2023 SWITCHGEAR UPGRADE RECORD DRAWINGS REDLINED FOR 2025 CHANGES	
W–058508–01A	PHYSICAL LAYOUT
W–058508–01B	BASE & SECTIONAL VIEW
W–058508–02	SINGLE LINE DIAGRAM
W–058508–03	NAMEPLATE DETAILS
W–058508–04A	GENERATOR 1 AC SCHEMATIC
W–058508–04B	GENERATOR 2 AC SCHEMATIC
W–058508–04C	GENERATOR 3 AC SCHEMATIC
W–058508–05A	FEEDER BREAKER/MASTER AC SCHEMATIC
W–058508–05B	FEEDER BREAKER/MASTER AC SCHEMATIC
W–058508–05C	VFD AC SCHEMATIC
W–058508–06A	GENERATOR 1 DC CONTROL SCHEMATIC
W–058508–06B	GENERATOR 2 DC CONTROL SCHEMATIC
W–058508–06C	GENERATOR 3 DC CONTROL SCHEMATIC
W–058508–07A	GENERATOR 1 DC CONTROL SCHEMATIC
W–058508–07B	GENERATOR 2 DC CONTROL SCHEMATIC
W–058508–07C	GENERATOR 3 DC CONTROL SCHEMATIC
W–058508–08A	GENERATOR 1 DC CONTROL SCHEMATIC
W–058508–08B	GENERATOR 2 DC CONTROL SCHEMATIC
W–058508–08C	GENERATOR 3 DC CONTROL SCHEMATIC
W–058508–09	MASTER DC CONTROL SCHEMATIC
W–058508–10	MASTER DC CONTROL SCHEMATIC

**KWETHLUK M&I 2025
IMPROVEMENTS PROJECT
ISSUED FOR CONSTRUCTION
MAY 2025**

ALASKA ENERGY AUTHORITY		
PROJECT: KWETHLUK M&I 2025 IMPROVEMENTS		
TITLE: SCHEDULE OF DRAWINGS		
 P.O. 111405, Anchorage, AK 99511 (907)349-0100	DRAWN BY: BCG	SCALE: NO SCALE
	DESIGNED BY: BCG	D

CUSTOMER ALASKA ENERGY AUTHORITY			
CUSTOMER JOB No. 21116			
DRAWN BY JRV	AUTH BY JRP	DATE 02-15-23	REV 3
DRAWING/FILE No. W-058508-02		SHEET 2

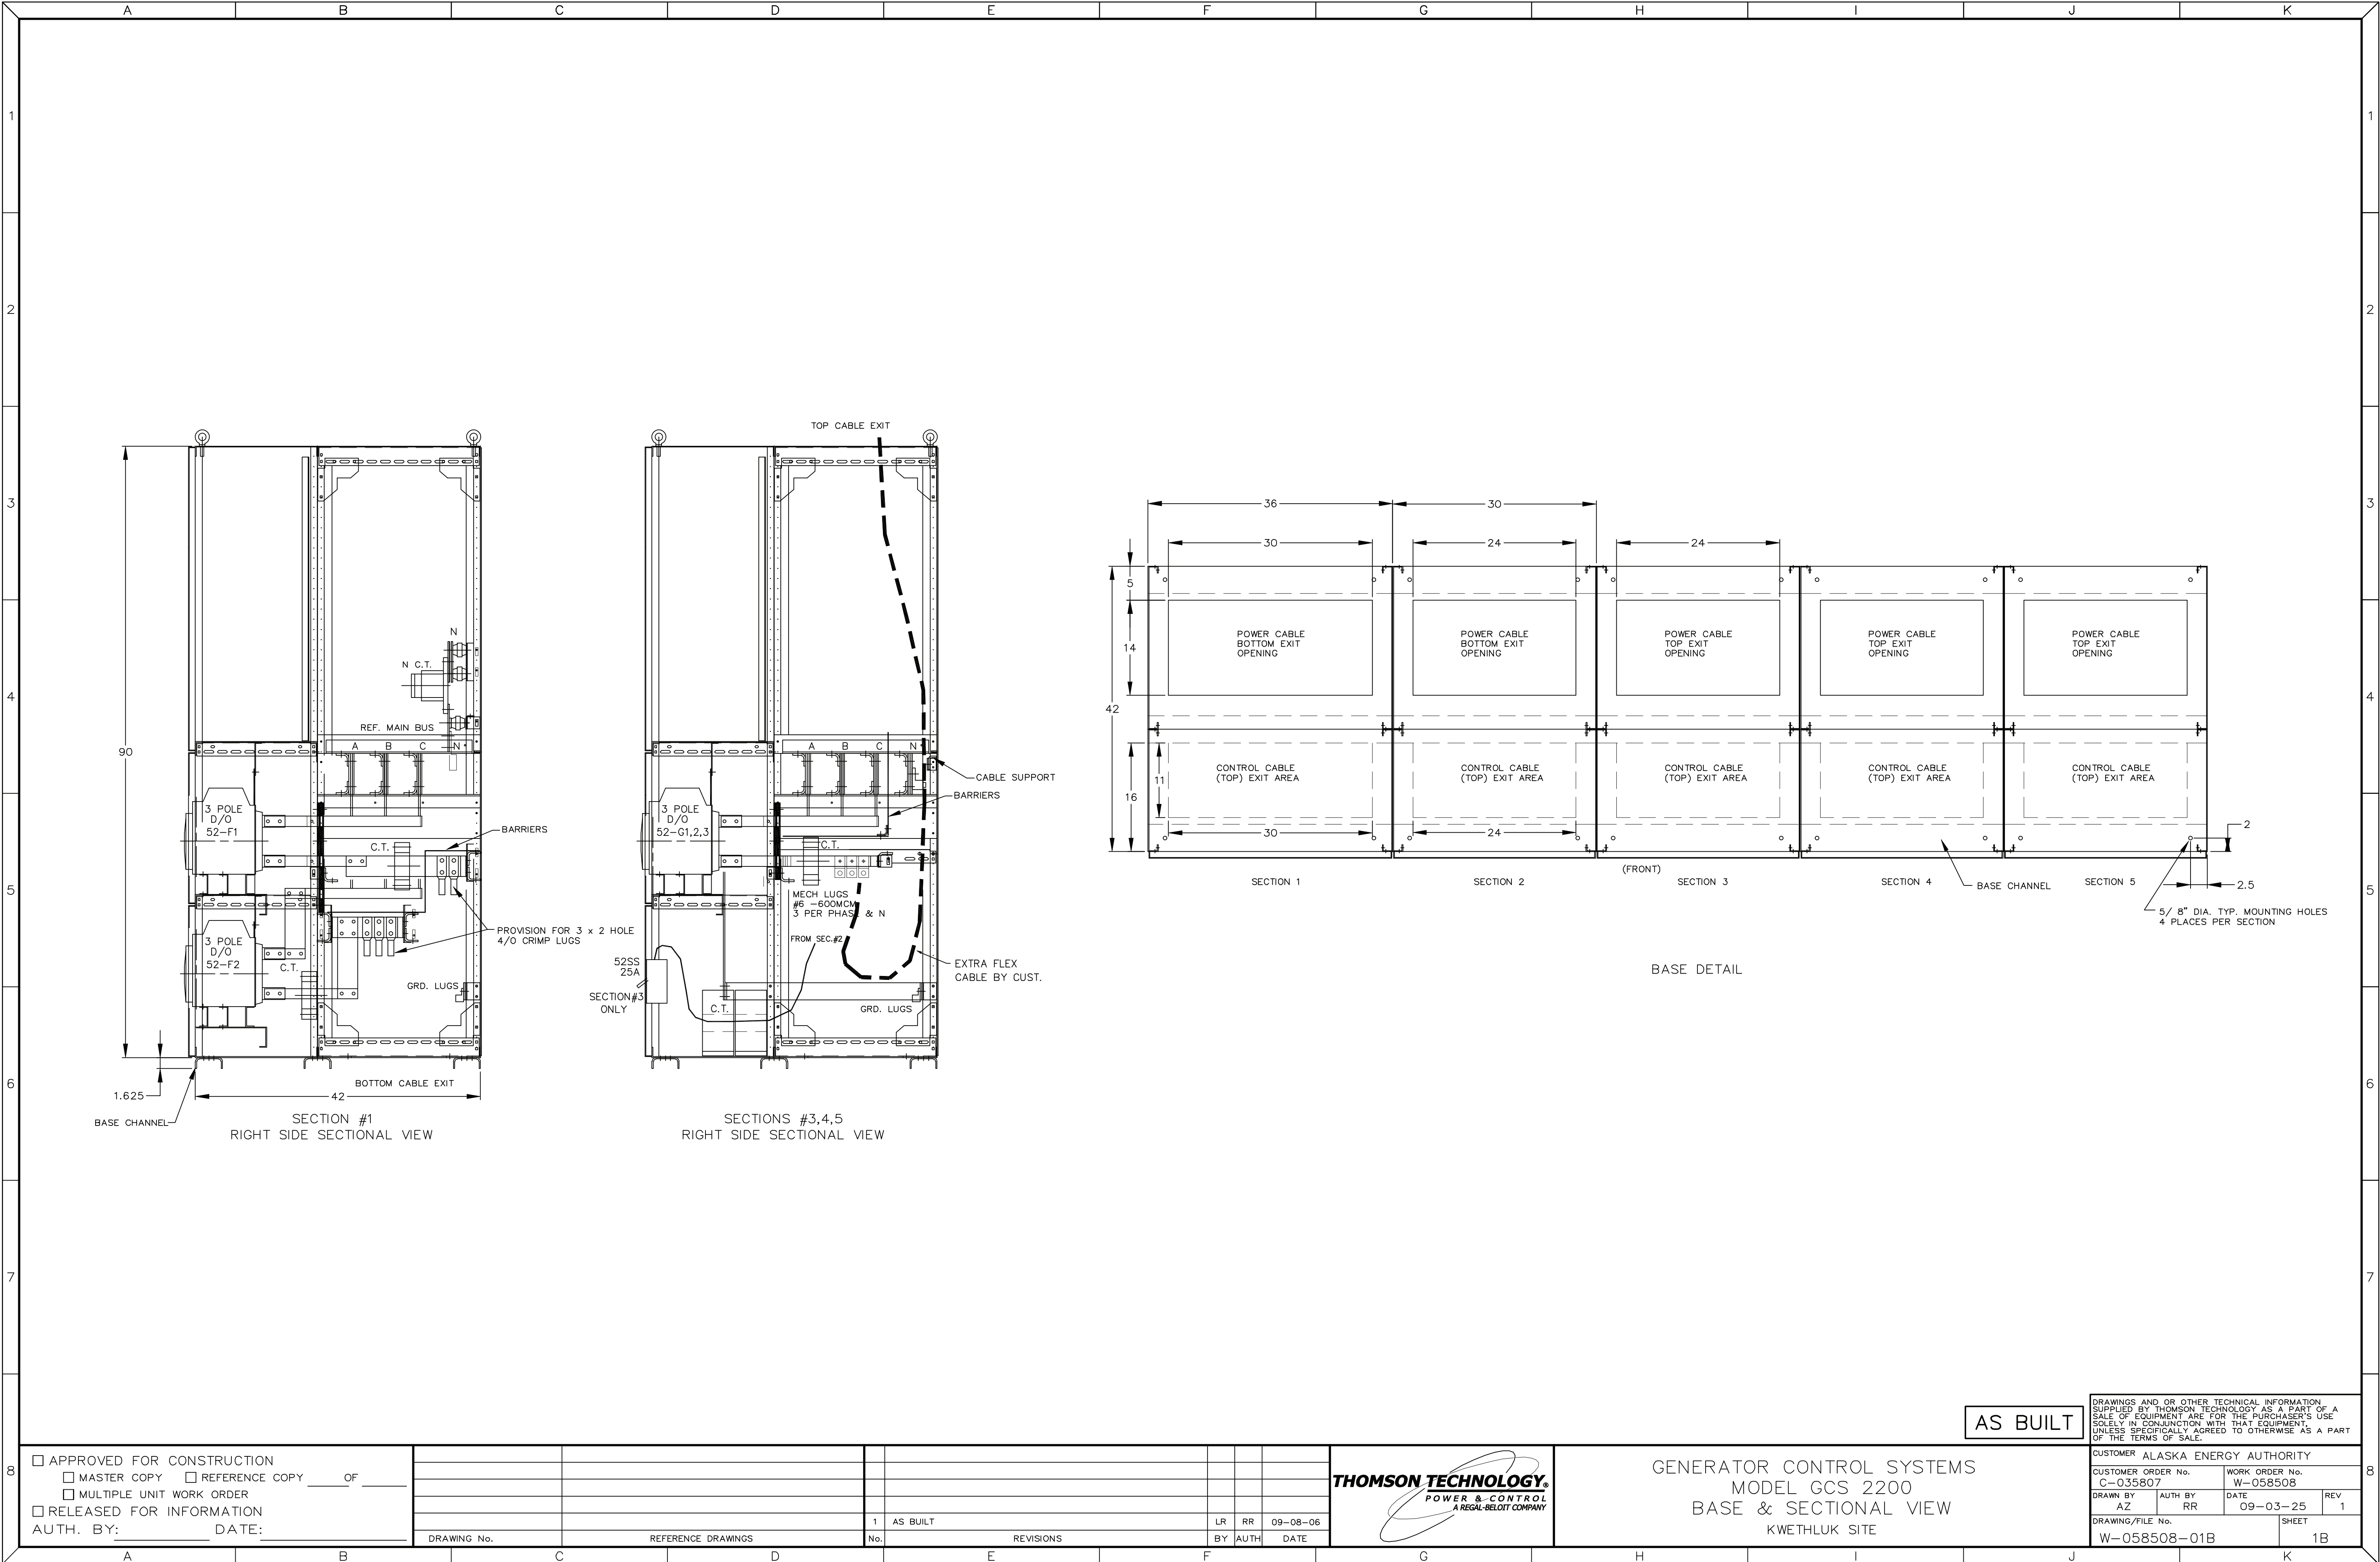
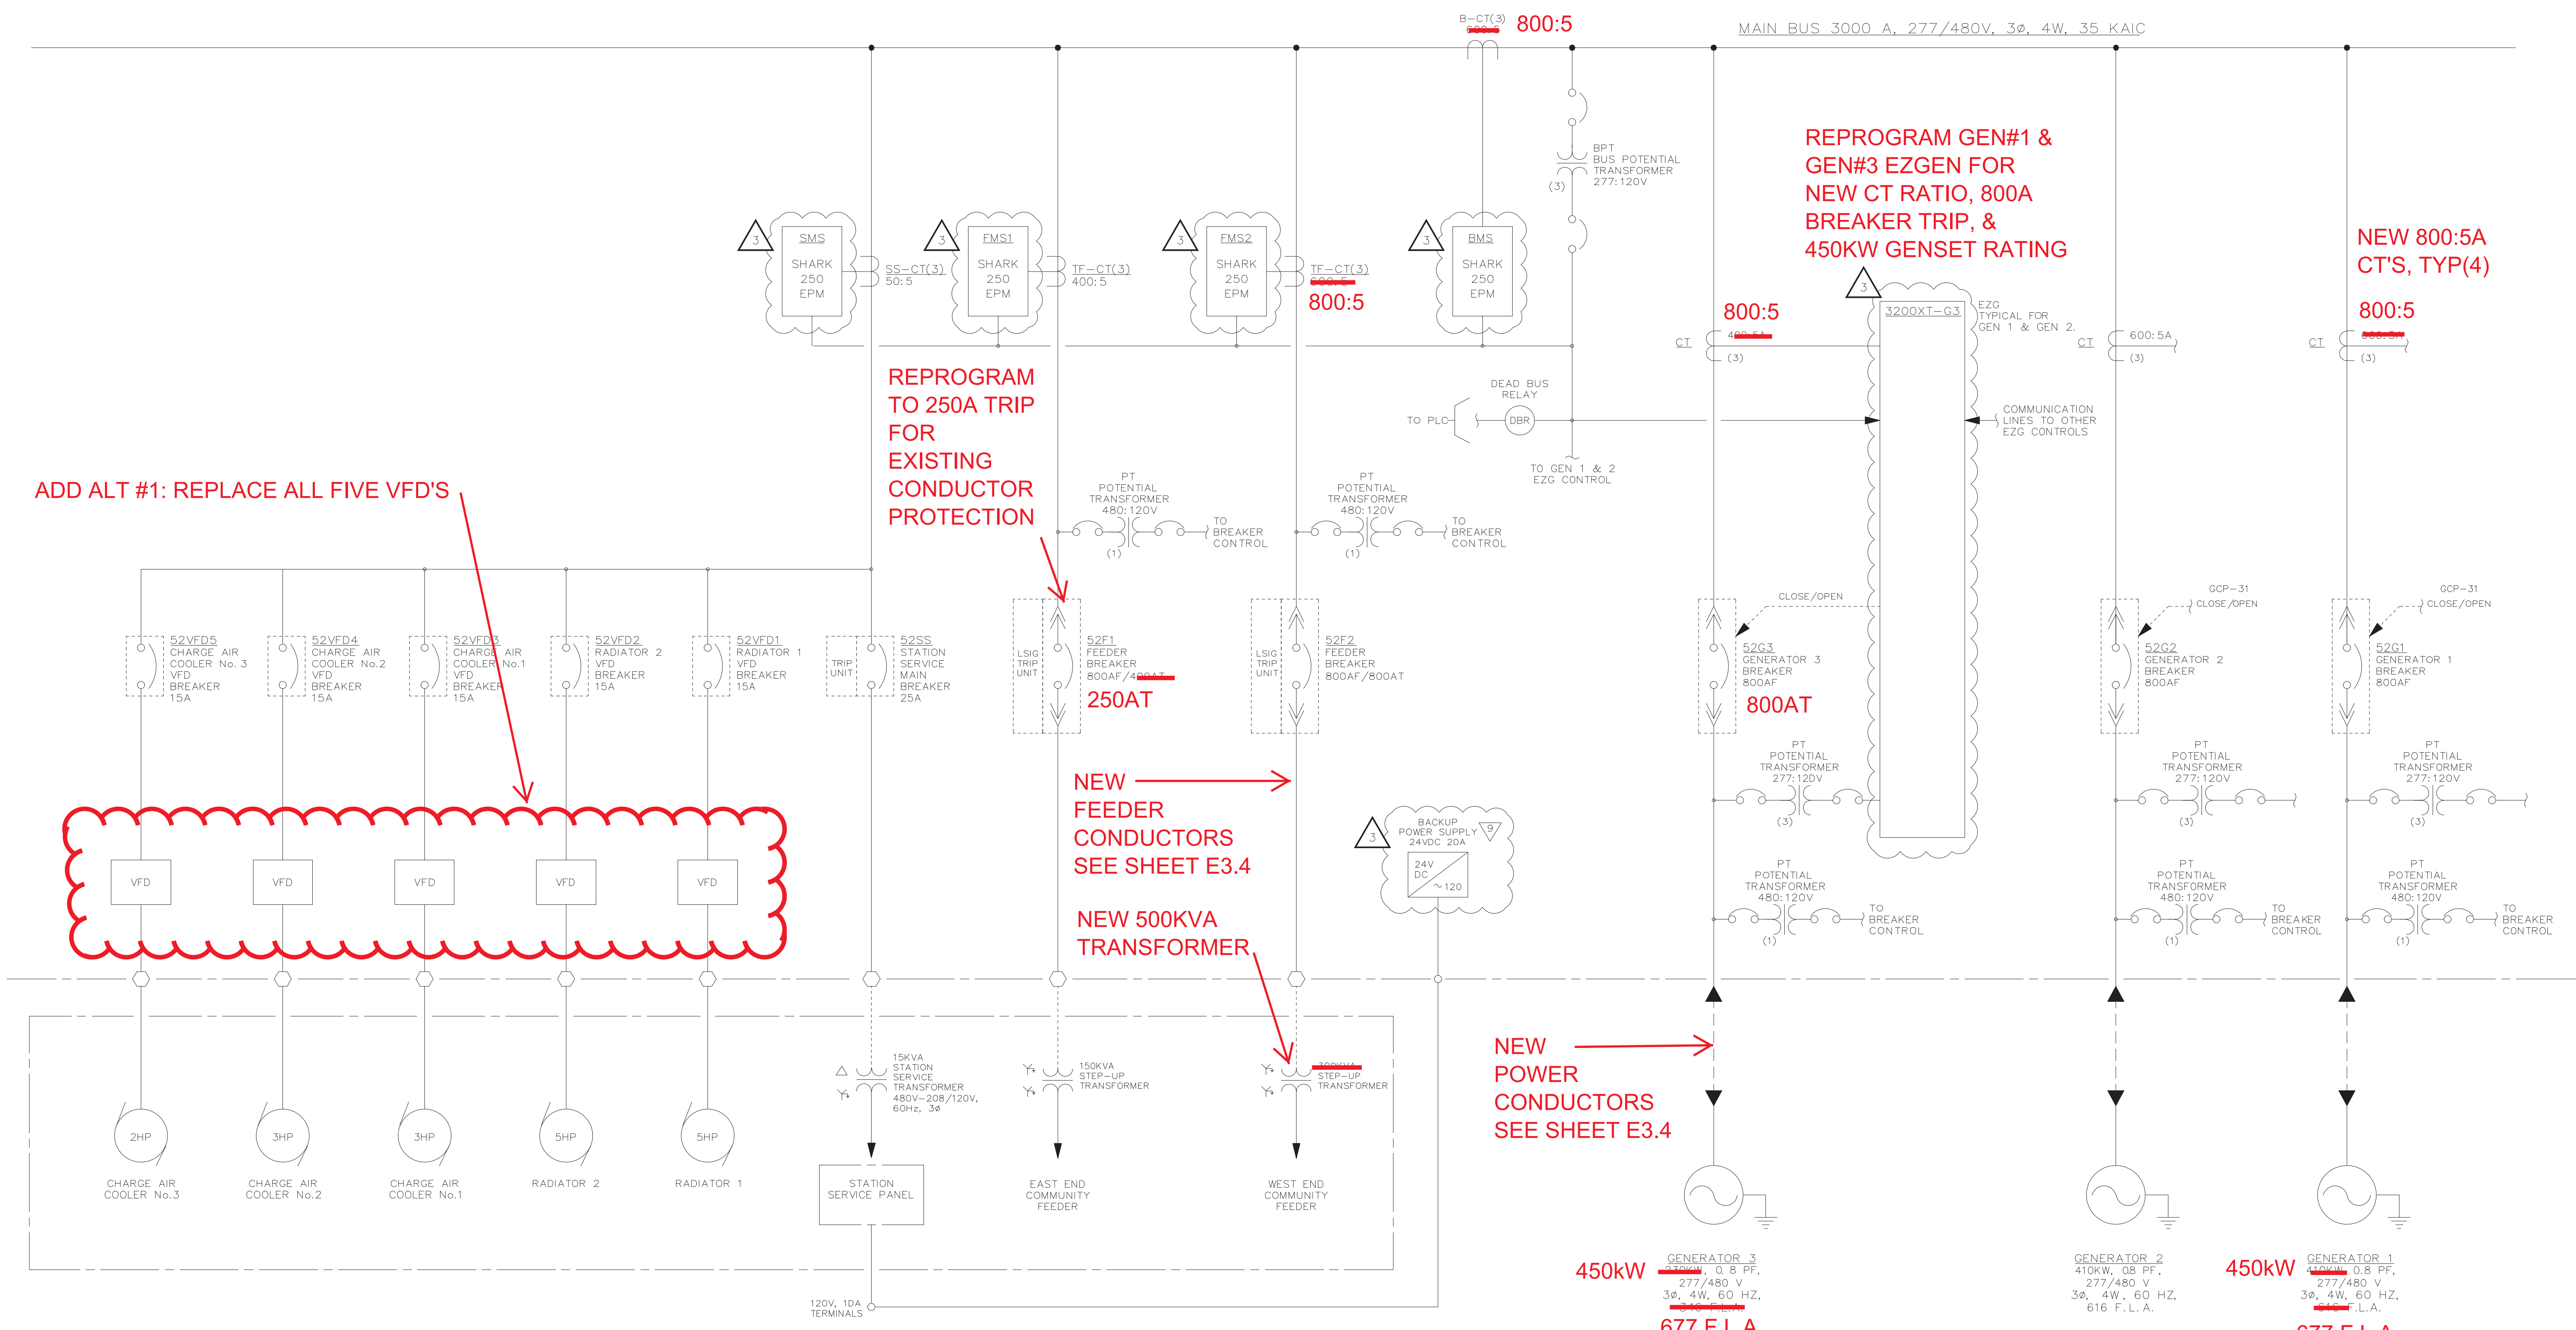
SEE 2025 M&I PROJECT SHEET E6.1 FOR TASK SPECIFIC GENERAL AND SPECIFIC NOTES

CUSTOMER ALASKA ENERGY AUTHORITY			
CUSTOMER JOB No. 21116			
DRAWN BY JRV	AUTH BY JRP	DATE 02-15-23	REV 3
DRAWING/FILE No. W-058508-04B			SHEET 4B

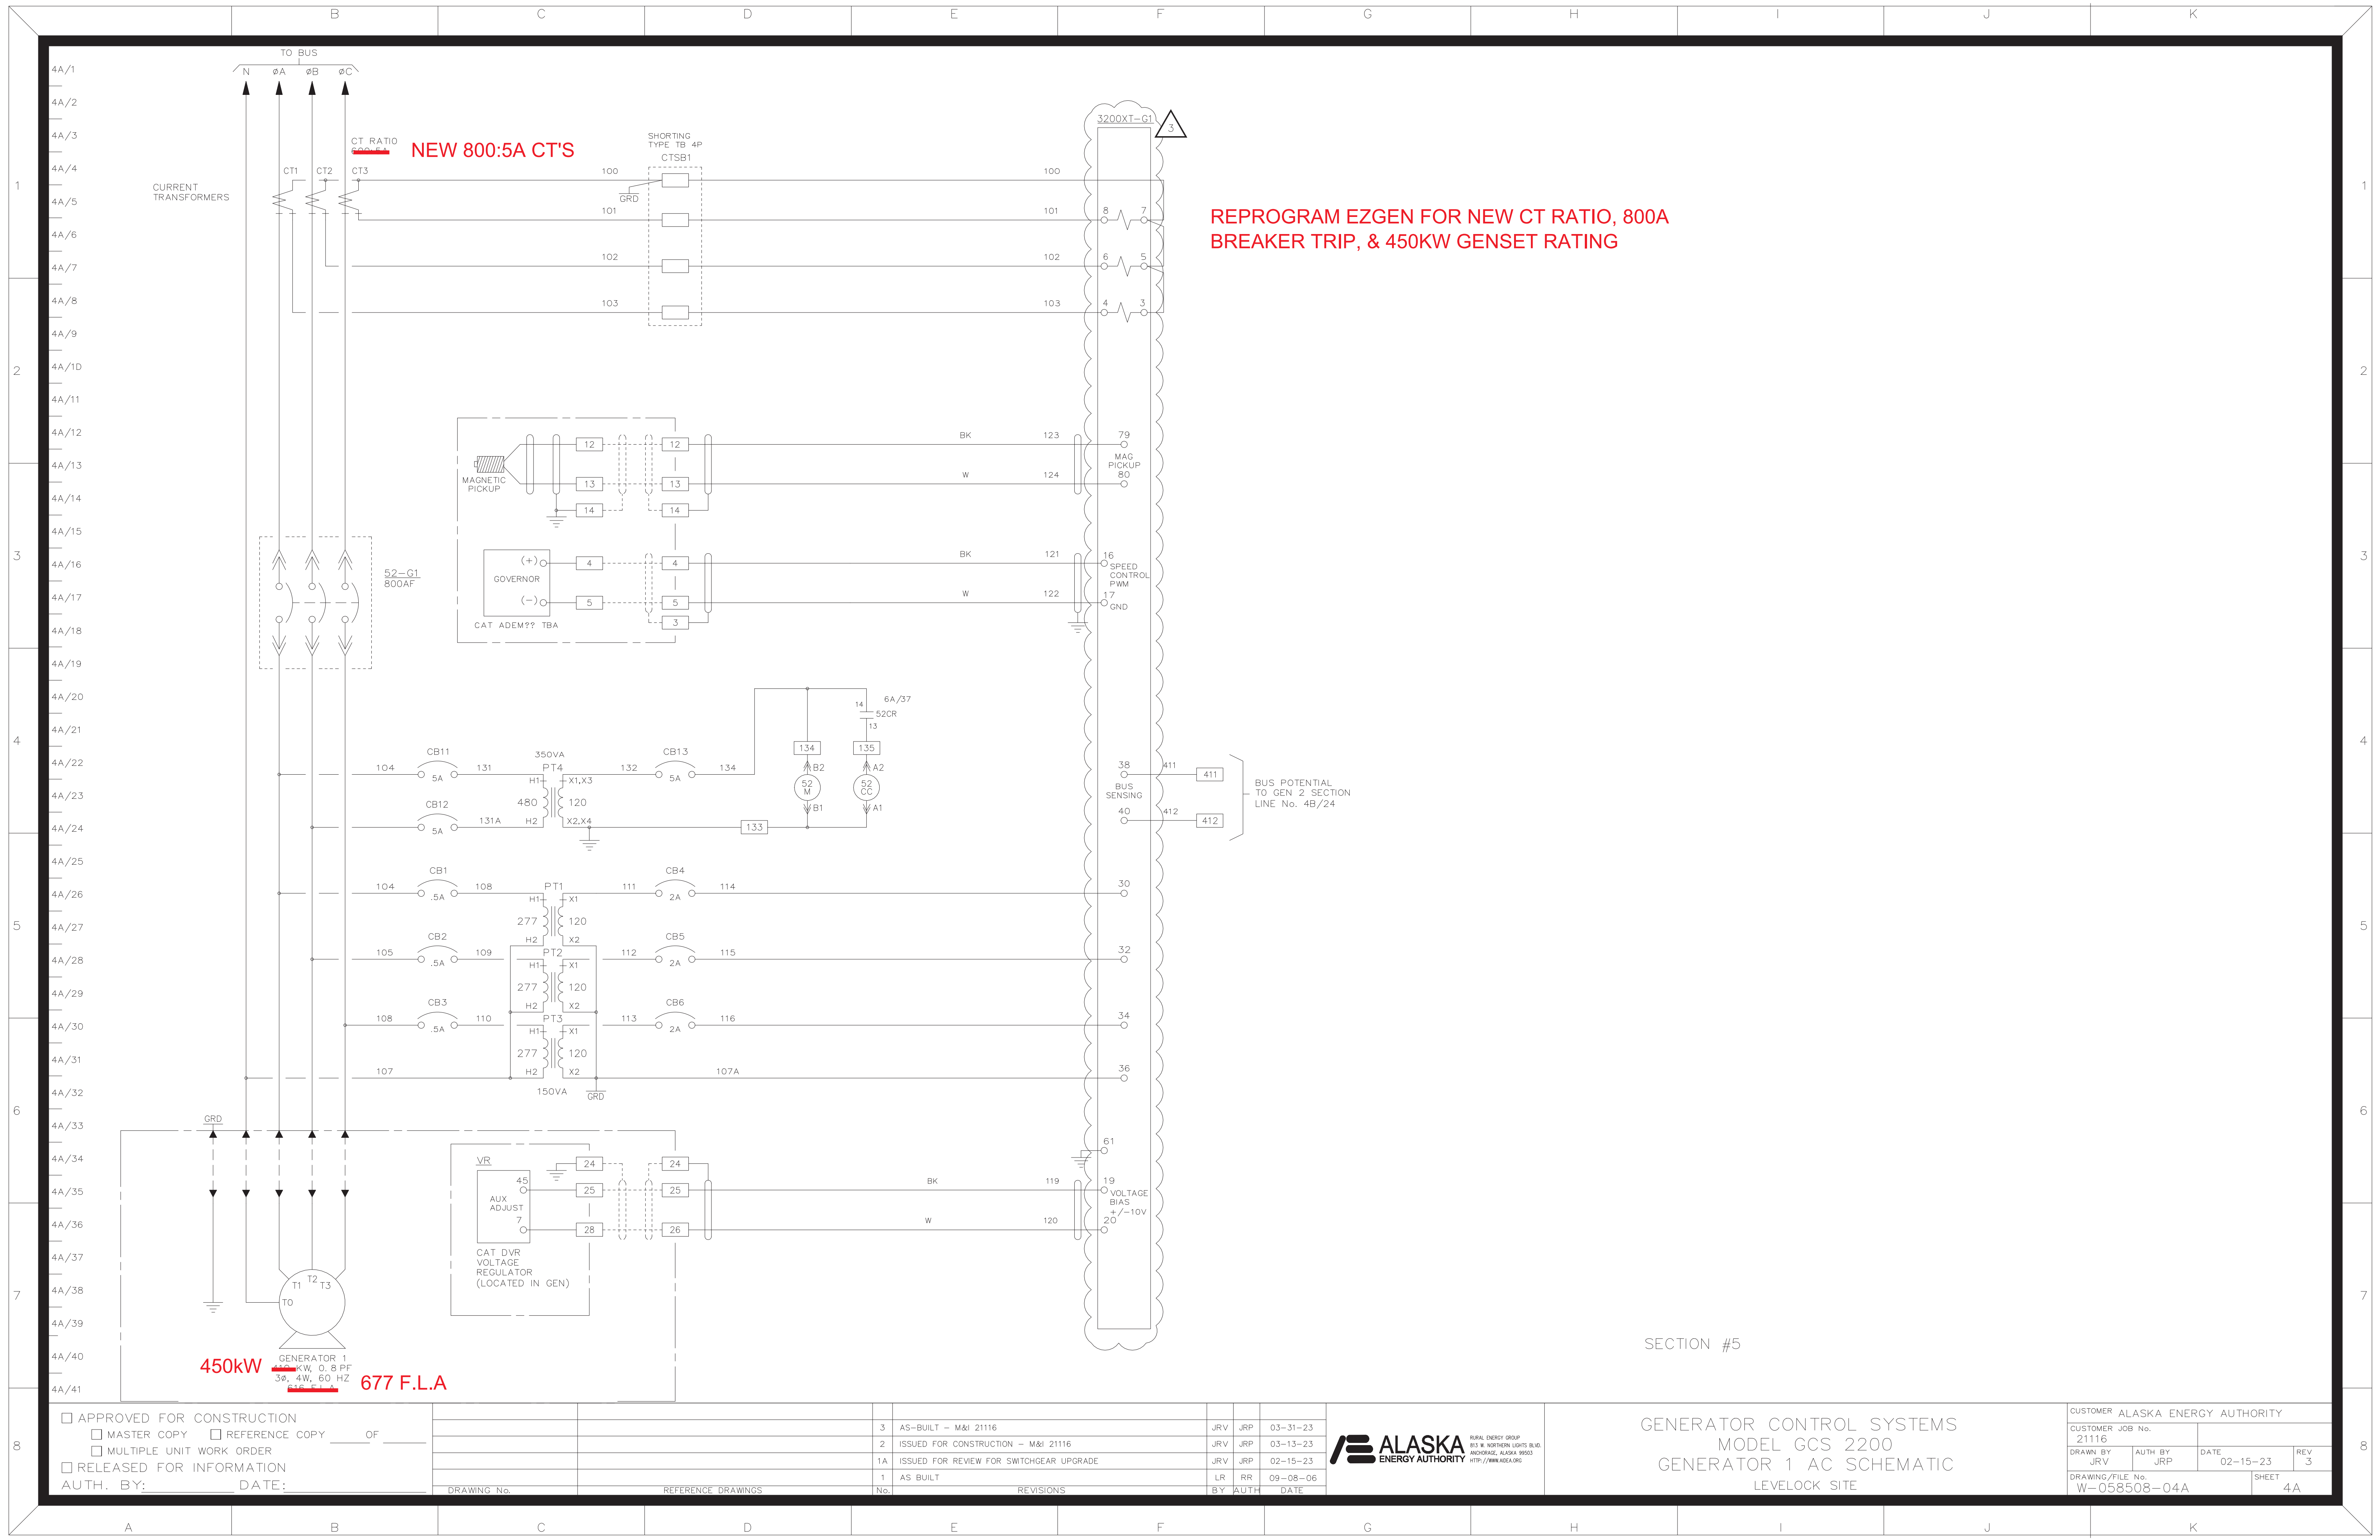
REPROGRAM EZGEN FOR NEW CT RATIO, 800A
BREAKER TRIP, & 450KW GENSET RATING
